DART Field Inspection and Modification: Tank inspection & modification of (2) center Door Latches Part Number 10712198		
Work Instructions Initial Release: 2/18/2014	REVISION:	DOCUMENT: WI-078

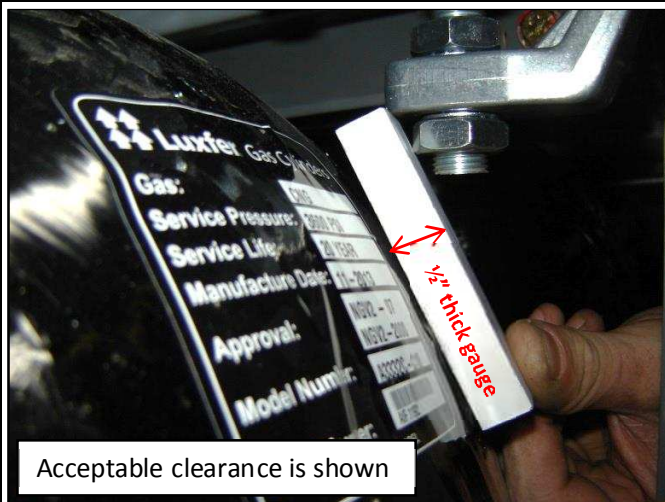
5.1.3 The potential contact condition is shown in the photo.

- 5.3 PERFORM MANDATORY MODIFICATION OF (2) CENTER DOOR LATCHES**
- 5.3.1 See illustrations for exact locations
 - 5.3.2 Using a portable band saw, make a length reduction cut on the threaded studs
 - 5.3.2.1 Make a ½" long reduction cut
 - 5.3.3 Apply Permatex Rust Treatment to ends of studs per directions on aerosol can
 - 5.3.4 Dispose of scrap portion of threaded studs

40' BUS

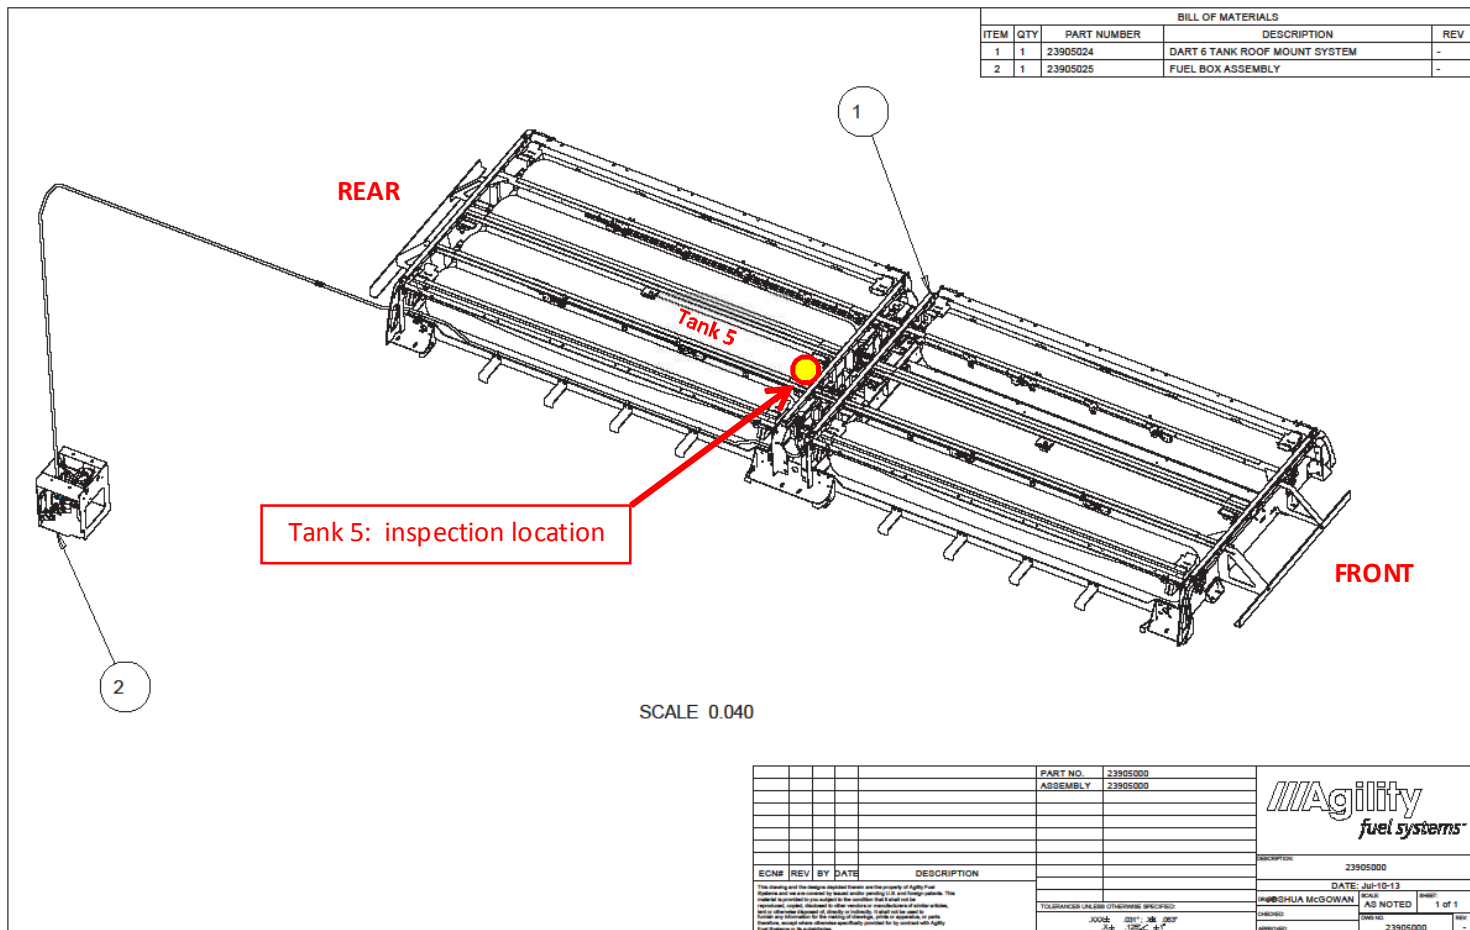
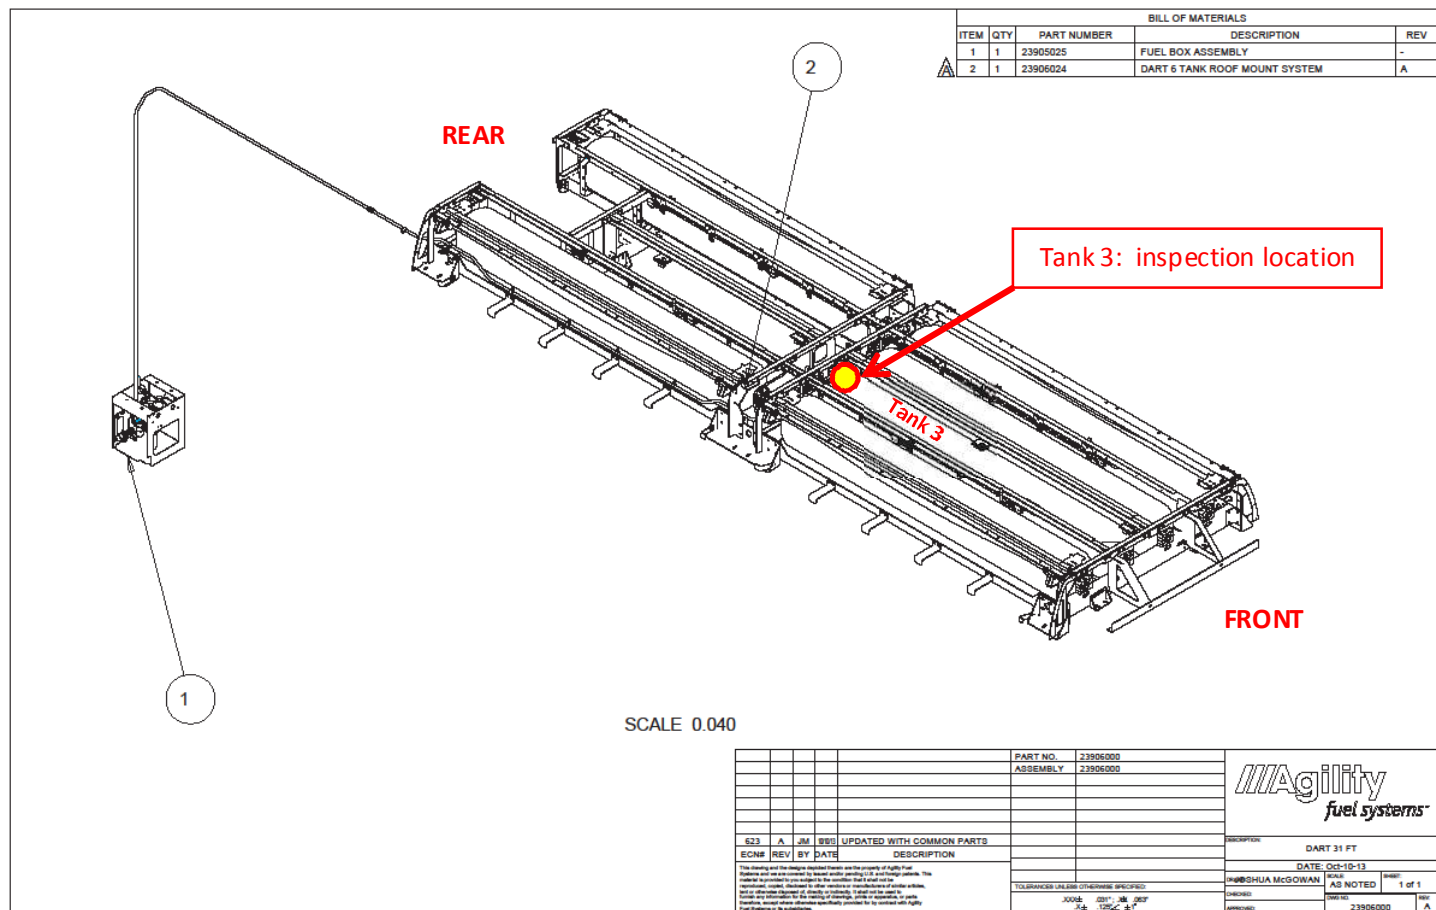
2.2.1 40' buses: Threaded stud contact with Tank 5 per the photos and illustrations in this work instruction

5.1.1 40' buses: Inspect Tank 5

5.1.4 The tank locations and possible stud contact locations are shown in the illustrations portion of this work instruction.

31' BUS

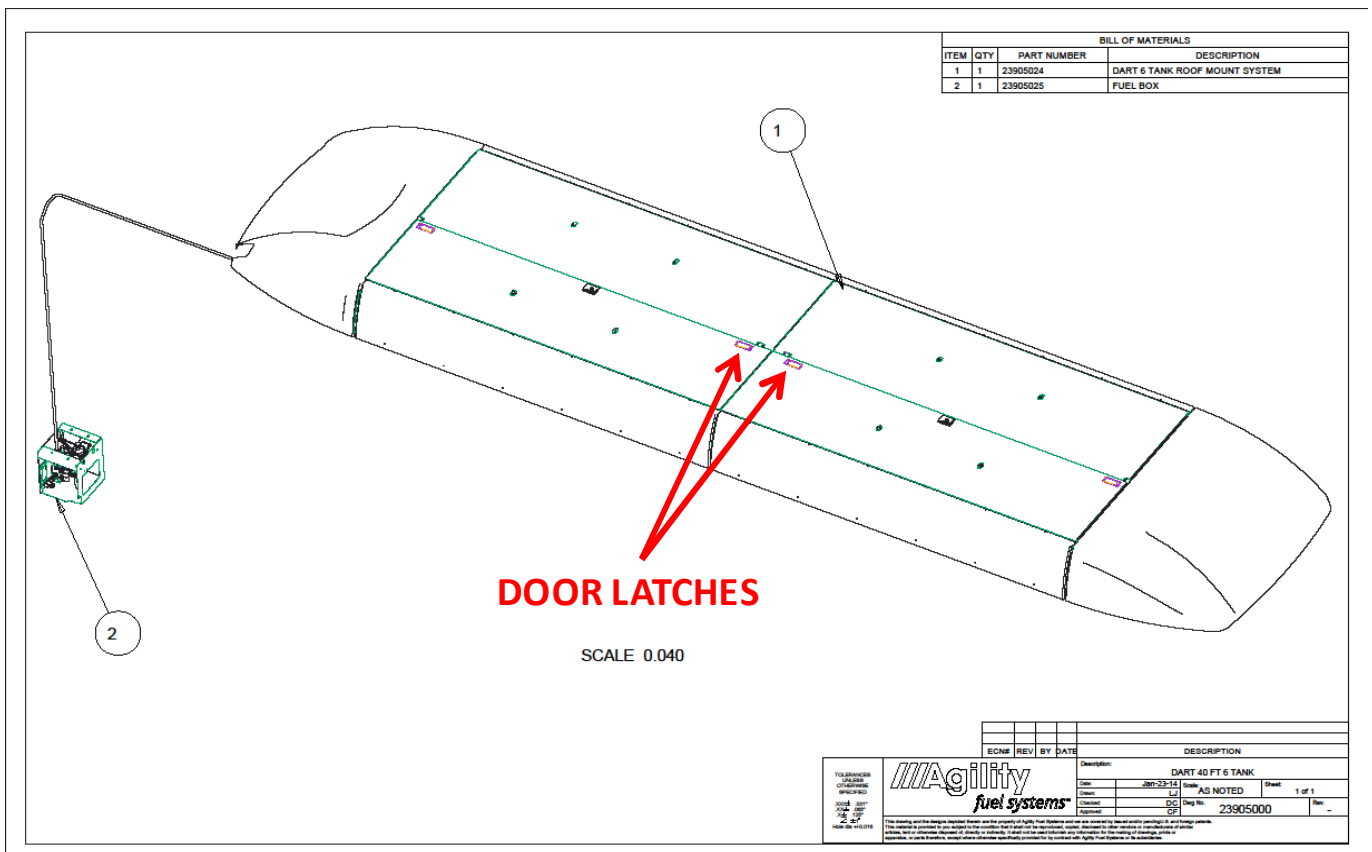
2.2.2 31' buses: Threaded stud contact with Tank 3 per the photos and illustrations in this work instruction

5.1.2 31' buses: Inspect Tank 3
